Central Planning Authority

Agenda for a meeting of the Central Planning Authority to be held on **May 24, 2023 at 10:00am in Conference Room 1038, 1st Floor, Government Administration Building, and Elgin Avenue.**

CPA/12/23

Figure 1: Extract from Meagre Bay Pond Protected Area Management Plan showing the application site (Block 48E Parcel 110) within the residential zone. (Meagre Bay Pond Protected Area Management Plan available from: www.conservation.ky)

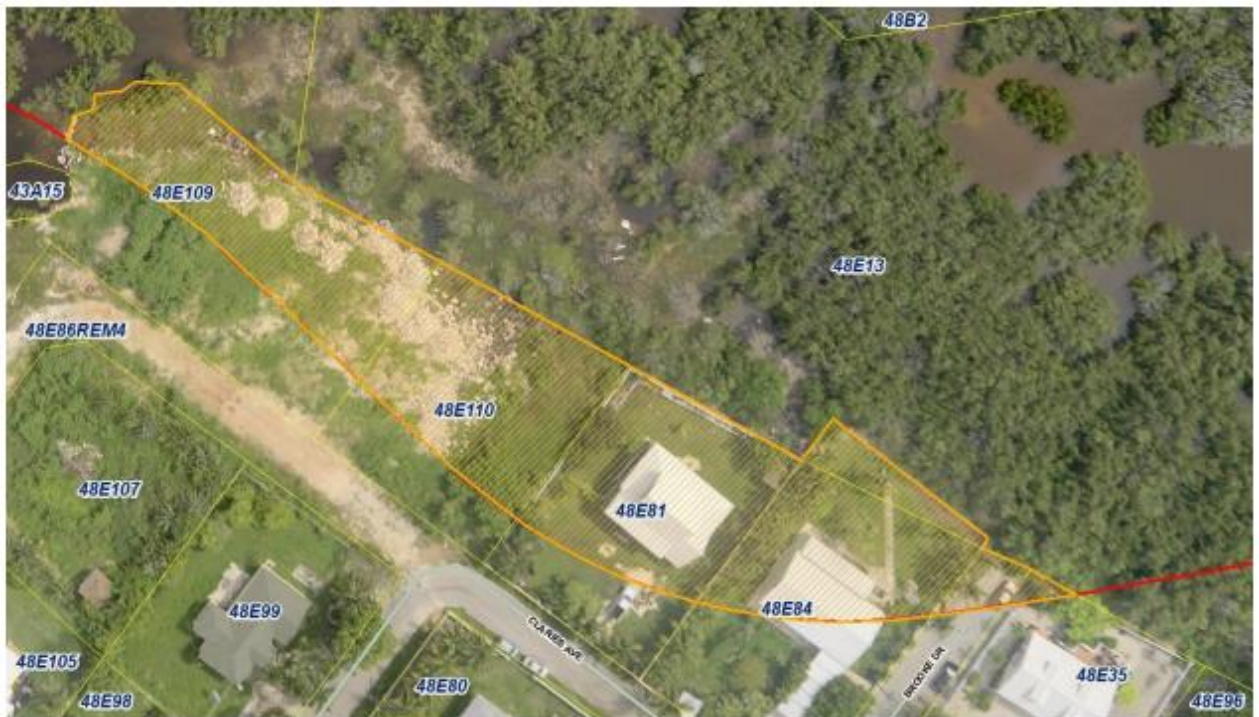
The purpose of this zone is to rationalise past mistakes made in the approval of a subdivision which extended into the former Animal Sanctuary (now a Protected Area under the National Conservation Act).

We highlight that under the Protected Area Management Plan for Meagre Bay Pond (2022), the following Directives apply to landowners and residents within the Residential Zone of the Meagre Bay Protected Area:

- *No expansion of habitat modification for human uses in the Protected Area is allowed beyond the Residential Zone boundaries as defined in this Management Plan.*
- *The only active land use change permitted within the Residential Zone is for residential housing.*
- *Home owners and occupants in the Residential Zone may not dispose of any effluents, garbage, yard waste or any other waste materials into the adjacent Protected Zone.*
- *Home owners and occupants in the Residential Zone may not allow pet dogs, cats or other domesticated animals to roam into the Protected Zone.*
- *Within the Residential Zone and subject to any other law and other directives for this zone, the provisions of Section 32 (b – f) of the National Conservation Act are not enforced.*

These Directives must be adhered to. Failure to adhere to the Directives set in the Meagre Bay Pond Protected Area Management Plan constitutes an offence under the NCA.

Figure 2: The aerial imagery of the site showing the application site (outlined in red) (Source: LIS, 2018).

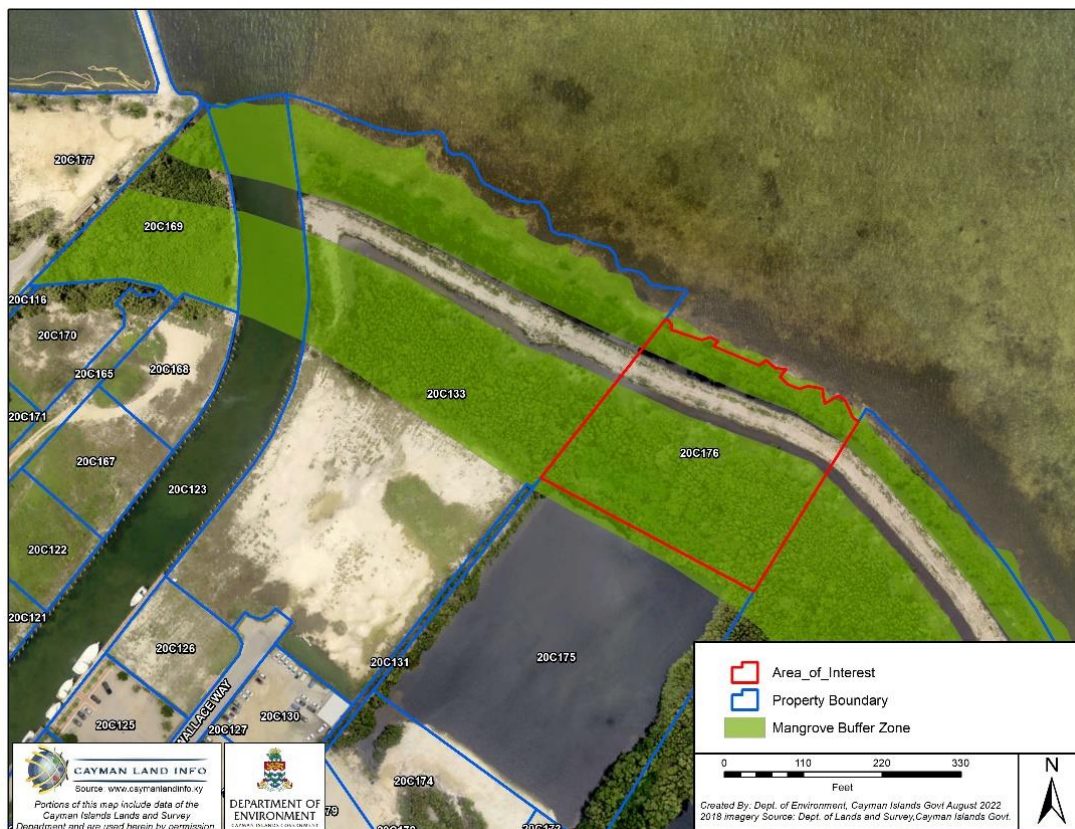
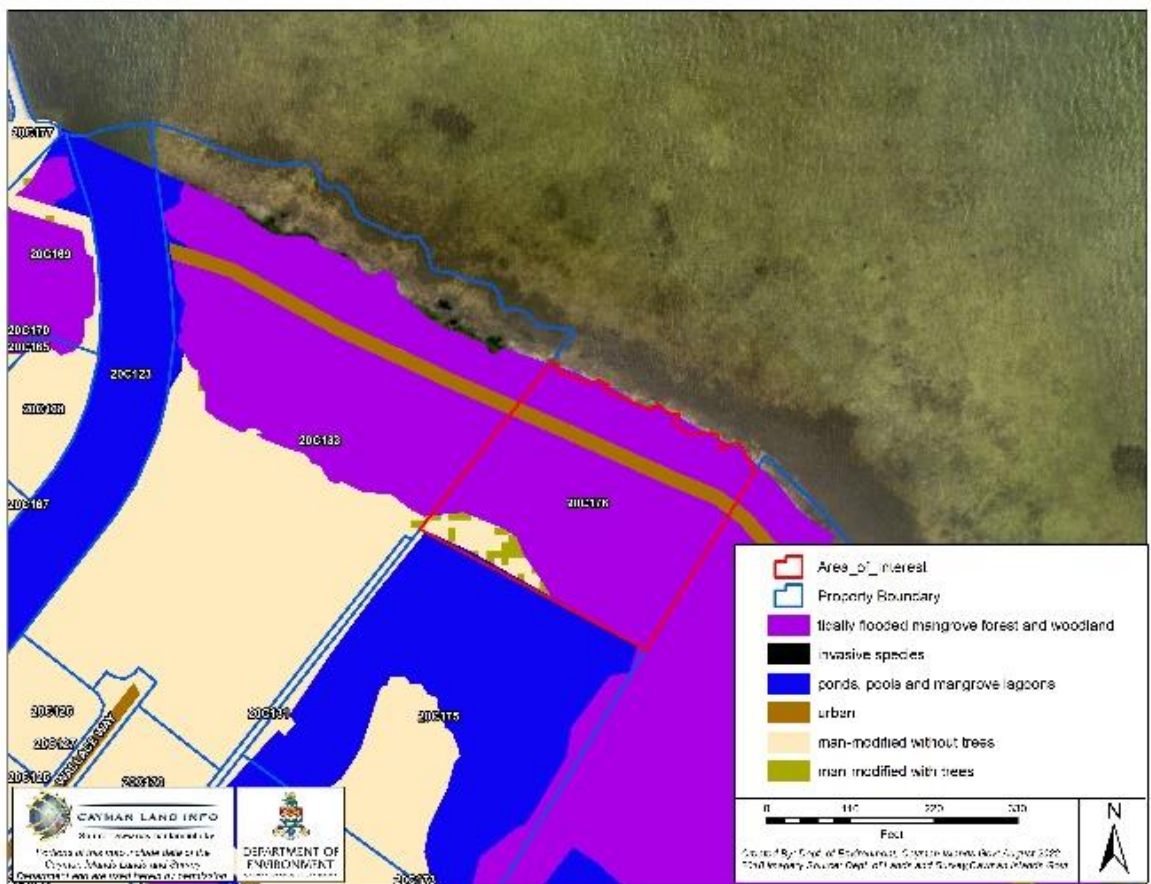
The application site consists of primary tidally flooded mangroves and secondary growth and incorporates part of the Mangrove Buffer Zone as shown in Figure 1.

Mangroves are a Part 2, Schedule 1 Protected Species under the National Conservation Act with an adopted Conservation Plan. Mangrove forests are a critical part of our natural environment, providing ecosystem services including mitigating the effects of climate change. As one of the most productive coastal habitats, mangrove wetlands are extremely biodiverse and provide habitat and food for an immense variety of species. Mangrove wetlands are extremely effective at sequestering carbon from the atmosphere and serve as carbon sinks. The large scale removal of significant tracts of mangrove habitat reduces the island's natural carbon sequestration potential. The removal of mature vegetation and de-mucking of the site has the potential to release stored carbon back into the atmosphere. Therefore, mangroves are an important natural asset. They also form part of Cayman's Natural Capital Accounts) and the removal of these mangroves reduces this asset and their ecological services.

Figure 2 shows the site proposed to be excavated as part of this planning application. Figure 3 shows the habitat at the site.

Figure 4: LIS 2018 showing an example of an alternative canal route in purple to link the lake to North Sound for boating access while preserving the mangrove buffer.

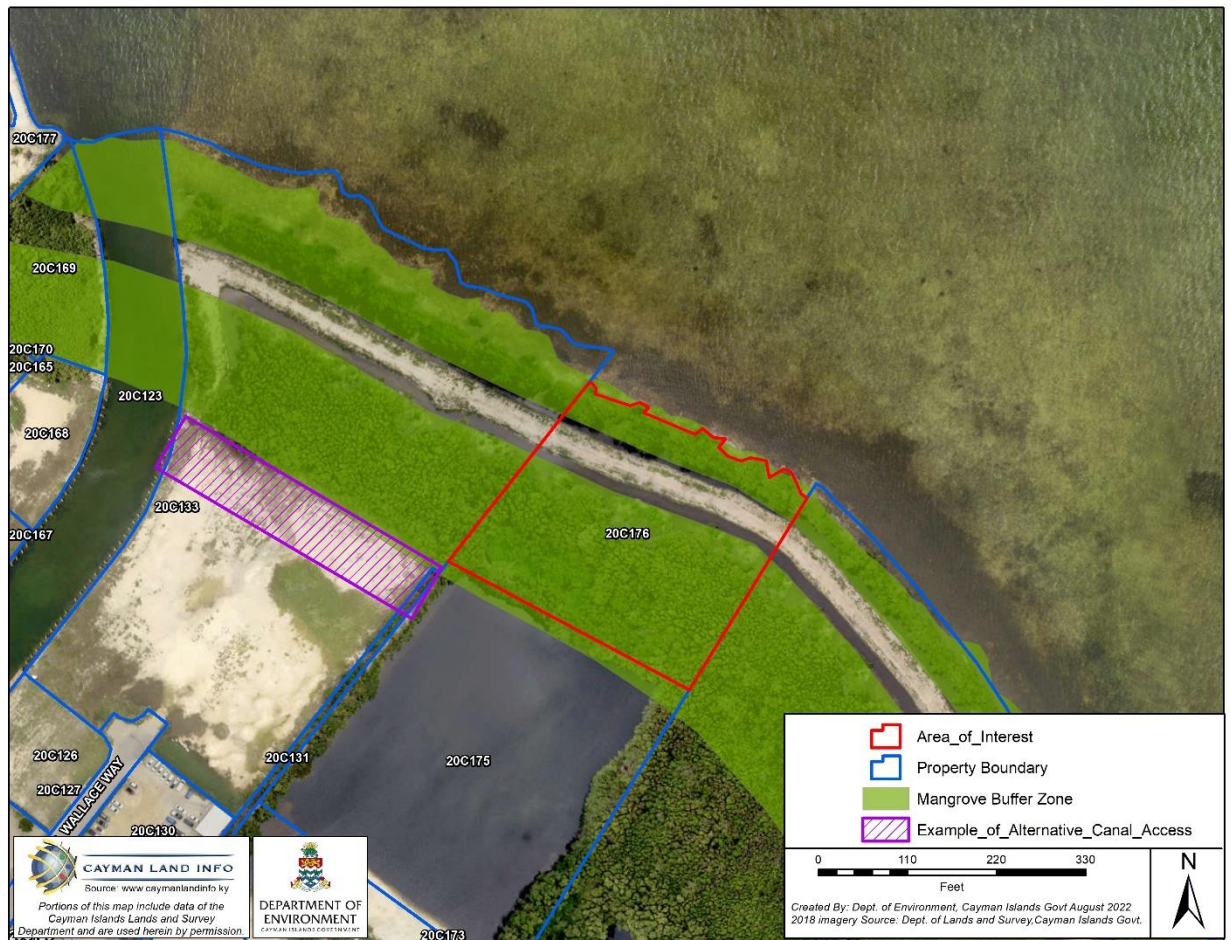
Given that there is no development being proposed on the site, just the canal to an inland lake, it does not seem absolutely necessary to gain safe boating access to an area with no development. There is a safe alternative for boating access from the parcel to the west at Block 20C Parcel 123. The applicant can negotiate access across Block 20C Parcel 133 and create an inland canal, which does not require going through the Mangrove Buffer Zone (Figure 4). This will allow the mangrove buffer to continue to provide ecological services and benefits including storm protection.

In addition to the loss of mangroves and their ecological services, the Department also has concerns about connecting the existing lake to the North Sound. When the connection is made between the existing excavated pond and the North Sound, there will be water quality impacts from the mixing of the stagnant water in the existing excavation with the water in the North Sound. The depth of the water in the inland pond, which was excavated around 2008, is unknown, and is not depicted on the application or the drawings. Any fine settled material on the bottom of the lake is likely preventing the reestablishment of marine growth and may cause fish kills and algal blooms. The canal will then be connected to the North Sound impacting those sensitive marine resources. There may be continual resuspension events and/or a long-term impact.

*Therefore, the Department **strongly recommends that this application is refused.** The DoE does not support the proposed inland canal given:*

Figure 5: Sargassum influxes accumulate in dead-end canals (Source: Department of Environment, 2014)

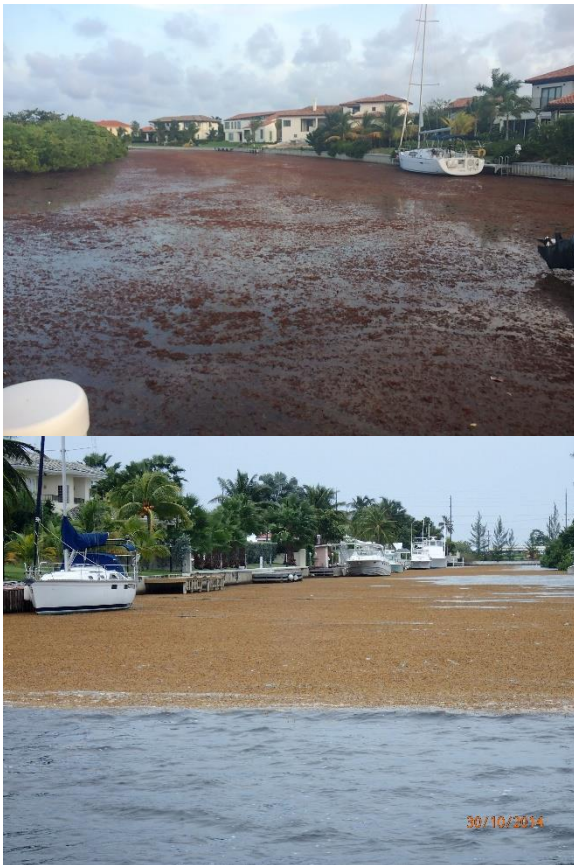
Lastly, given that this is a straight canal leading into a man-made lake with no flushing, it is likely that sargassum influxes will accumulate in the canal and result in poor water quality and odors (Figure 5).

Figure 2: The hatched area shows the portion outside of the setbacks as per the Development and Planning Regulations (2022 Revision), note that the proposed pool construction is located within the coastal setback (Aerial Imagery Source: UKHO, 2021)

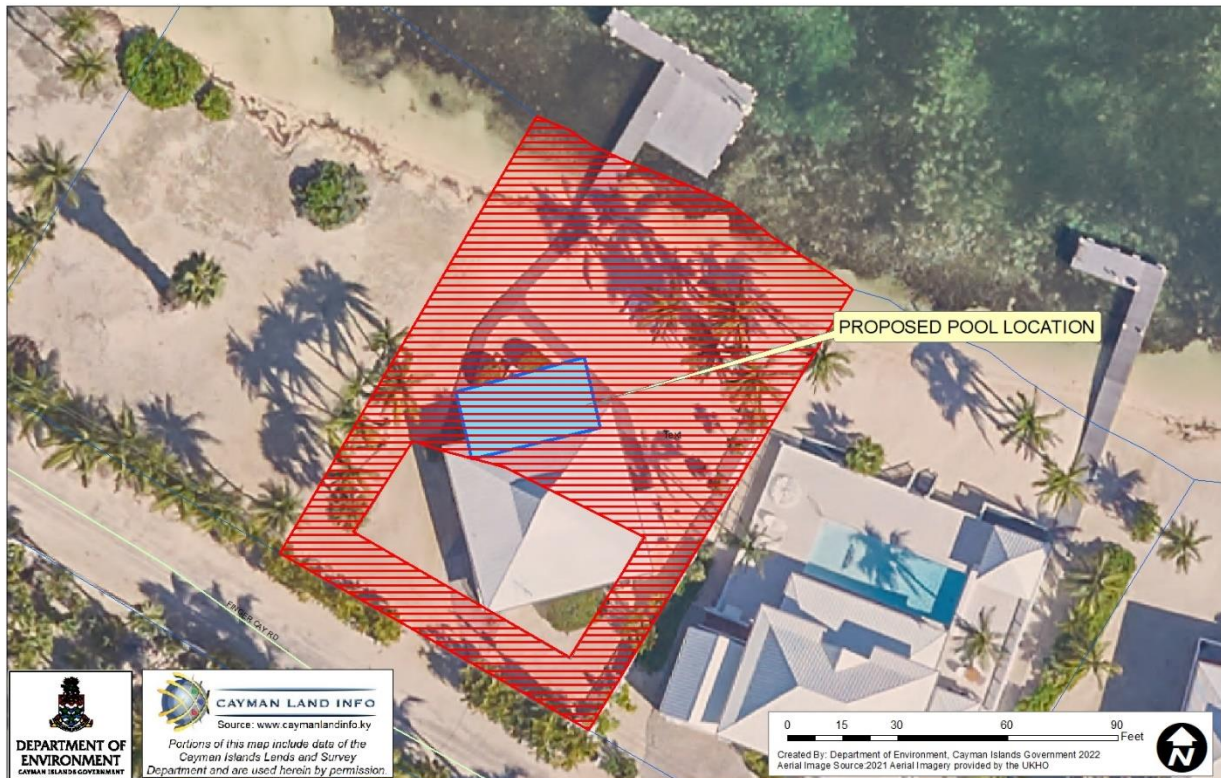
As shown in Figure 2, we note that both the setbacks of the existing structures on site, and the proposed setback of the pool are much less than the minimum required setbacks from the registered Mean High Water Mark under section 8(10)(b) of the Development and Planning Regulations (2022 Revision). Adherence to these absolute minimum setbacks is important, especially in the context of climate change predictions for the region, including sea level rise and increased intensity of storm events (including storm surge). The DoE would like to reiterate that these setbacks seek to provide protection to properties against these inevitable effects of climate change such as coastal flooding and erosion, by ensuring that hard structures are not located in an area susceptible to these hazards. We do note that this coastline is a man-made coastline and not subject to natural replenishment cycles and coastal processes, which reinforces the need for strict adherence to the minimum setbacks for coastal development. We recommend that the applicant explores other options for the location of the pool that would remove it from the 75'-0" minimum coastal setback (such as the south-west corner of the property, adjacent to Finger Cay Road).

Figure 1: Topography of South Sound drainage basin (outlined in red) and location of proposed road (outlined in yellow)

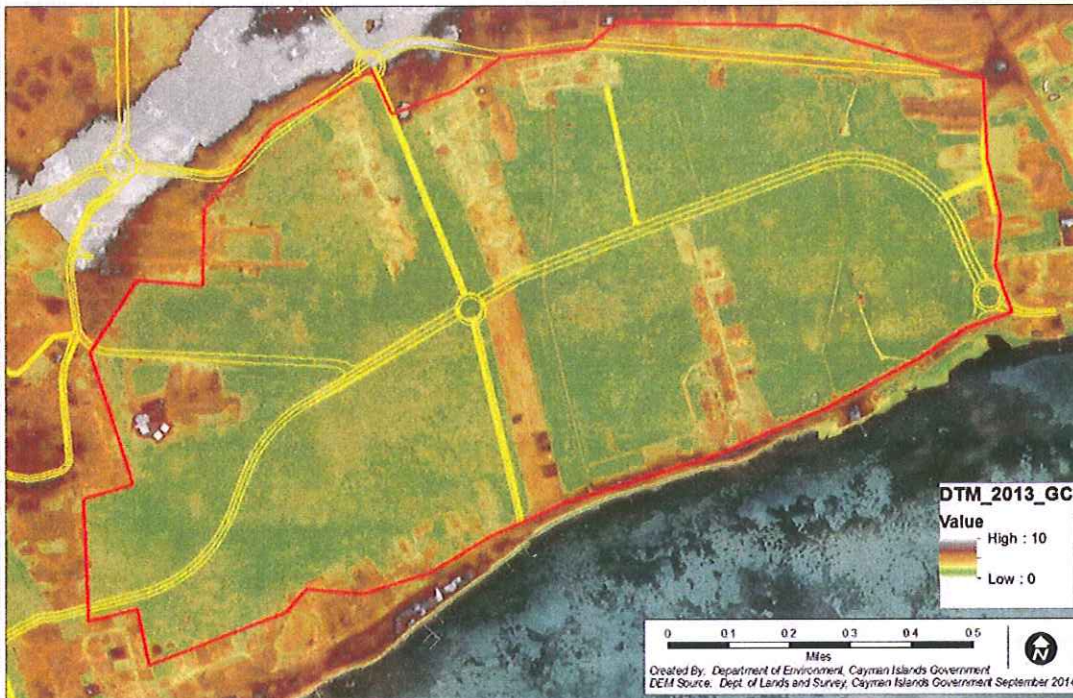
Proposed and existing developments including new roads in the South Sound drainage basin are shown in Figure 1 and Figure 2.

Unless the drainage and flooding issues in the area are addressed in a comprehensive manner, prior to these developments and the road coming forward, the agencies have grave concerns regarding the impacts of seasonal flooding on existing developments and on the quality of the receiving waters; i.e., the South Sound lagoon.

Figure 2: Aerial image showing permitted developments (highlighted in red) and proposed developments (highlighted in blue) within the South Sound drainage basin.

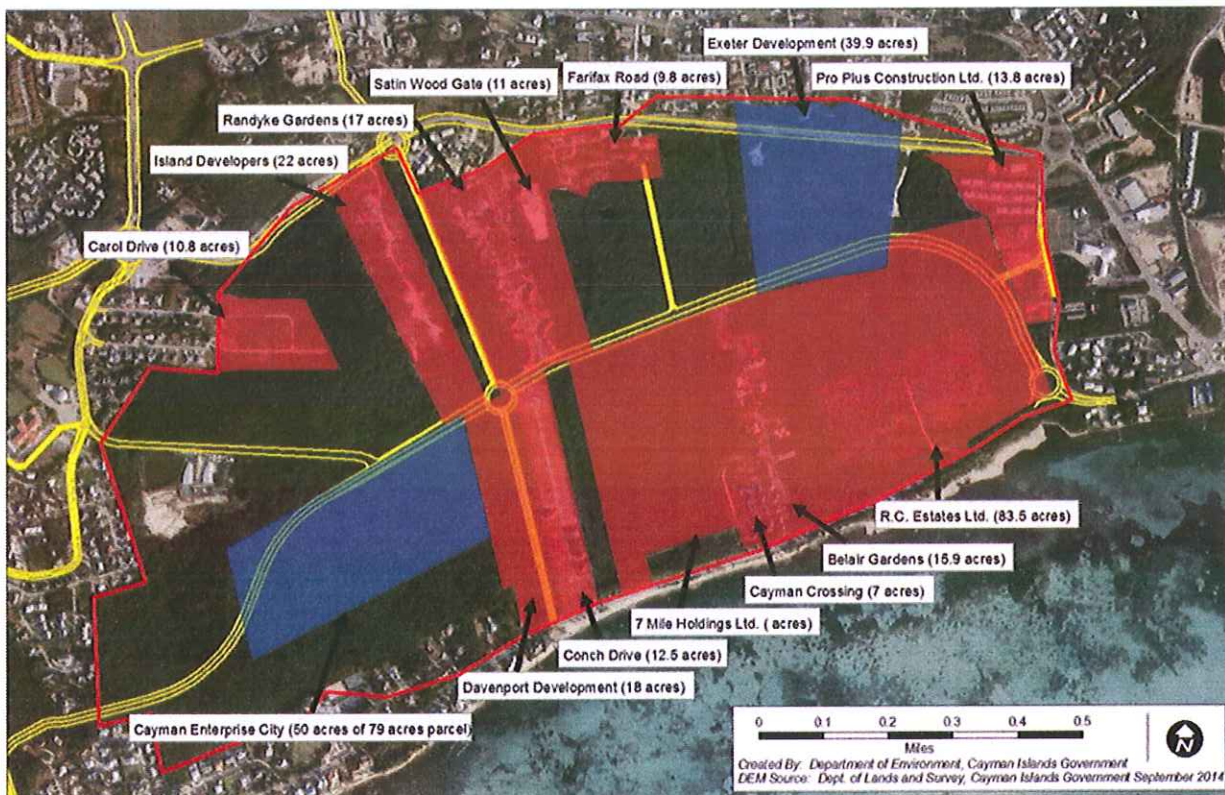
A number of existing developments in the basin become inundated with rainwater during the wet season; most notably Randyke Gardens. Several new residential subdivisions have been granted CPA approval in the past 3 years and, most recently, the agencies have been contacted by Cayman Enterprise City regarding a 50 acre development in the basin and an application has been received from Exeter Development Ltd for a 30-35 acre general commercial development to the south of Linford Pearson highway (comprising a large anchor grocery/retail outlet, with supporting ancillary retail and commercial development); see Figure 2.

The South Sound mangrove basin is a blocked non-tidal mangrove wetland which is impounded by the beach ridge and South Sound road to the south, and higher elevation, drier land as well as the Linford Pearson highway to the north. The beach ridge and roads are relatively impermeable to sea water and the mangrove swamp is flooded principally by rainwater. Historically, excess rainwater not retained by the extensive mangrove wetland basin gradually percolated through the beach ridge and mangrove coastlines along the length of South Sound lagoon. Following the construction of South Sound Road and the beginning of developments which reclaimed portions of the mangrove wetland, a series of MRCU physical control canals installed in the 1970's helped to alleviate storm waters and, more recently, a series of culverts were installed by PWD/NRA under South Sound road to drain the mangrove basin to the South Sound lagoon. However, the recent filling along the eastern end of the shoreline in South Sound has resulted in many of these culverts being blocked. The one remaining culvert, in close proximity to the Red Bay dock, is normally blocked by the NRA with a sheet of metal placed in front of the culvert; this culvert is made operational when required (see figures 3 & 4). Seasonal flooding of Randyke Gardens and other low-lying developments in the basin has become a normal occurrence and without a regional stormwater management plan, this flooding will get worse.
